September 6, 2011

**Re: Construction Storm Water Inspection at Pickerington Elementary School
Fairfield County
Permit Number: 4GC03486*AG**

Figure 1

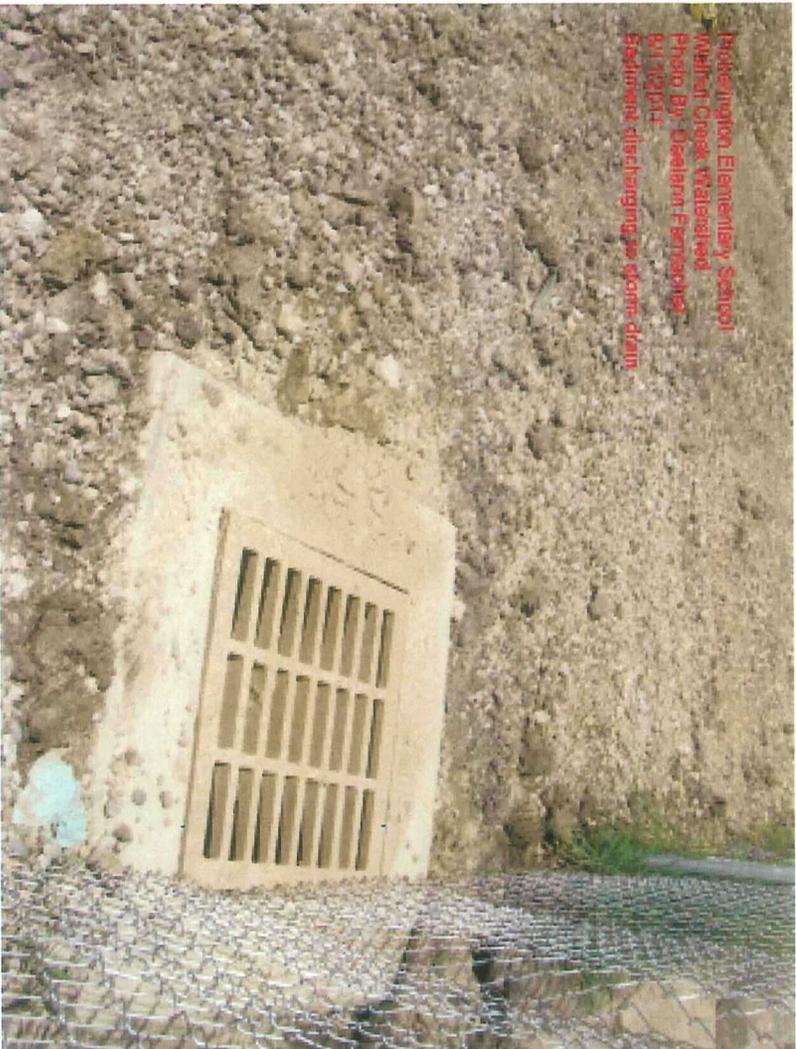
- The two storm drains located in the gravel entrance next to the project trailers require maintenance and appropriate inlet protection (see Figure 1).
- The storm drain located at the bottom of the dirt pile requires inlet protection with lateral support to minimize the discharge of sediment to waters of the state (see Figure 2).
- It was noted that the silt fence has failed on the south end of the site and will require reinstallation.
- Be aware the General Permit states that all barren areas which remain idle in excess of 21 days must be protected from erosion within seven days of the last earth disturbing activities. In addition, erosion protection must be implemented for all areas of final grade within seven (7) days.
